OHIO DEPARTMENT OF TRANSPORTATION
CENTRAL OFFICE, 1980 W. BROAD ST., COLUMBUS, OHIO 43216-0899

Re: 2009 Third Quarter Revisions

Revisions have been made to the ODOT Bridge Design Manual, July 2007. These revisions shall be implemented on all Department projects with a Stage 2 plan submission date after July 17, 2009.

Summary of Revisions to the July 2007 ODOT BDM

FIGURE 303.5.1-6

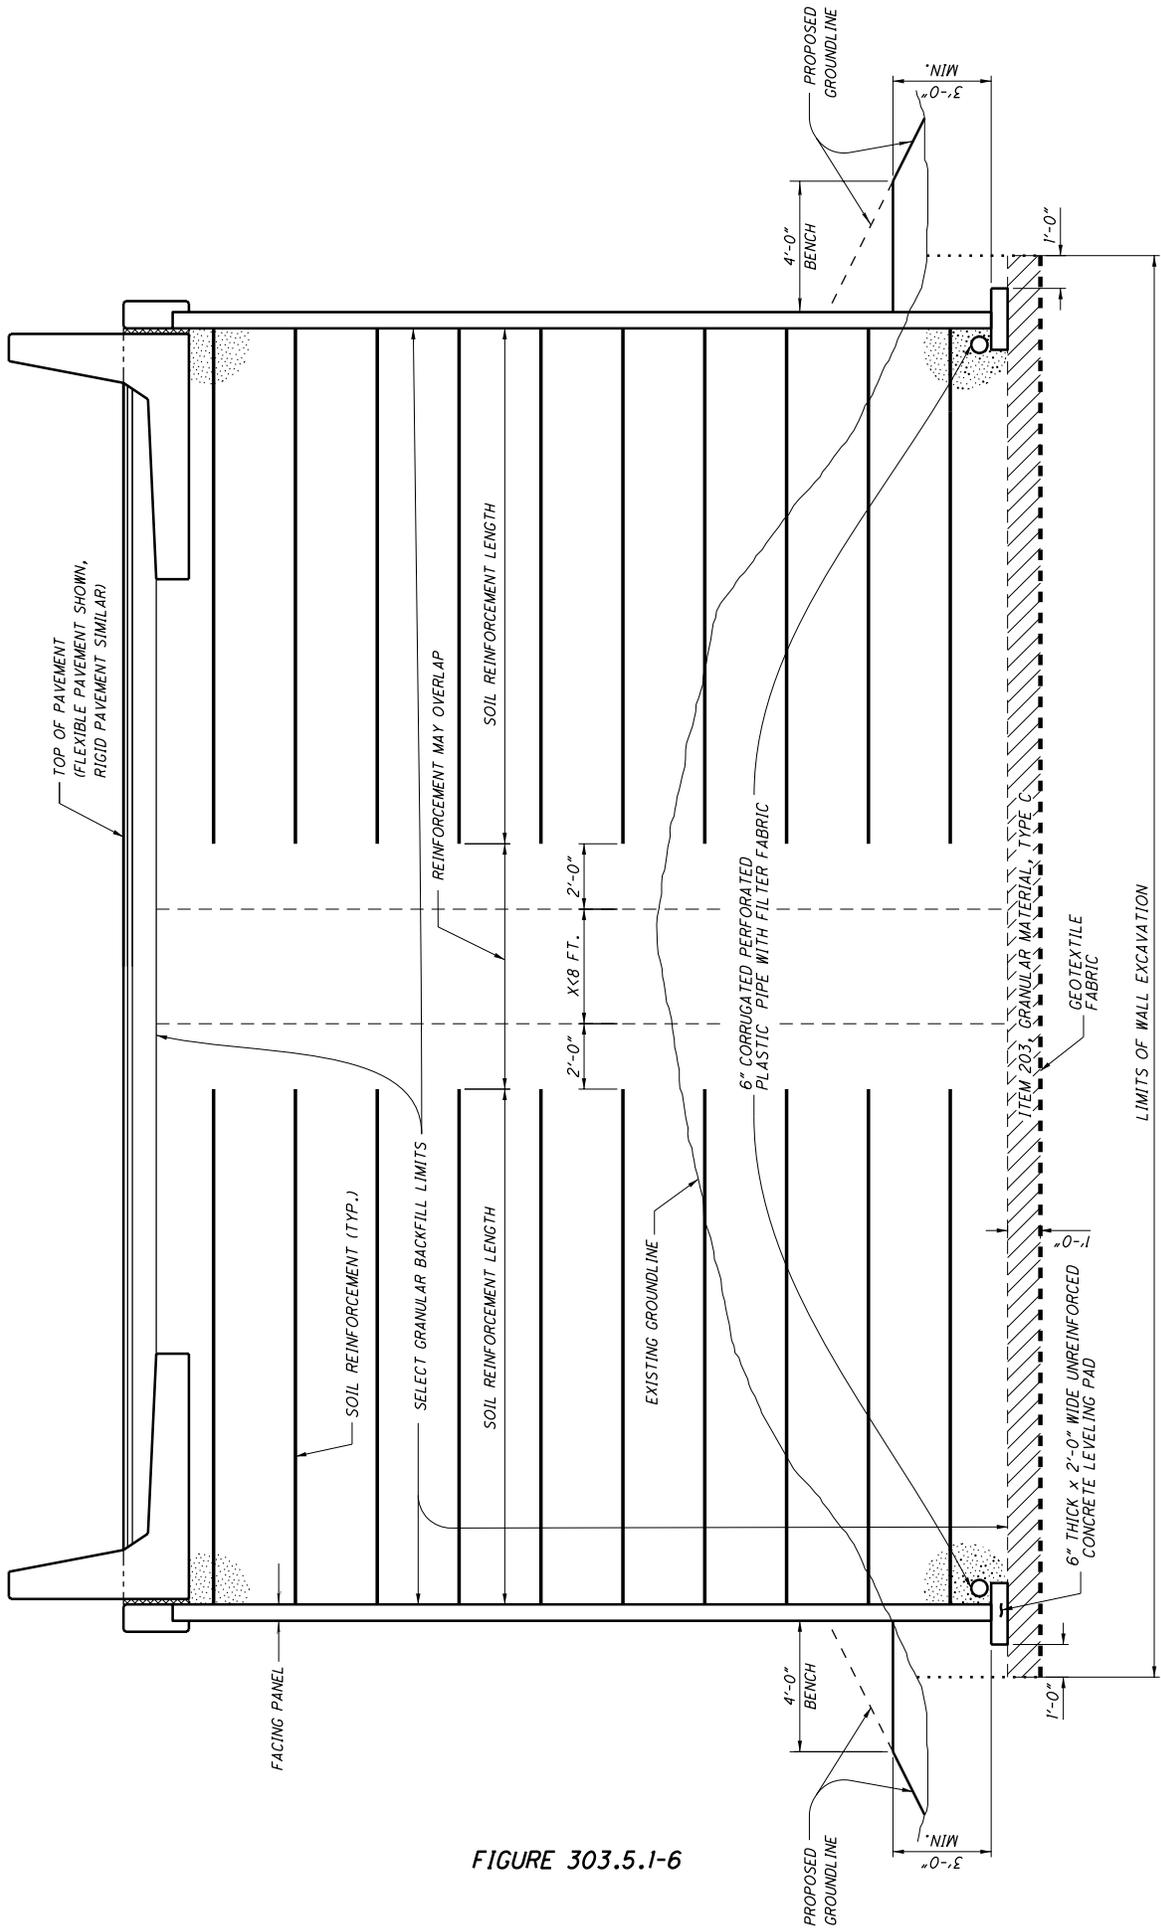
BDM Section	Affected Pages	Revision Description
Figure 303.5.1-6		This figure was revised to reflect a revision to SS840. Specifically, the required 3-ft layer of Item 304 material at the base of the MSE wall fill has been eliminated.
Figure 303.5.1-7		This figure was revised to reflect a revision to SS840. Specifically, the required 3-ft layer of Item 304 material at the base of the MSE wall fill has been eliminated.
802.1.2	8-2	The N-value correction table has been revised to reflect the ODOT Specifications for Geotechnical Explorations sampling requirements and the AASHTO LRFD Bridge Design Specification Article 10.4.6.2.4 correction factors.
Figure 801-1		A new metal wall supplier, Centria, has been added to the approved list. Also, the company name for the acrylic wall supplier, Cyro Industries, has changed to Evonik Cyro LLC.

IF X IS LESS THAN 8 FT., USE SELECT GRANULAR BACKFILL MATERIAL BETWEEN SOIL REINFORCEMENT. SEE ROADWAY PLANS FOR PAVEMENT BUILD UP
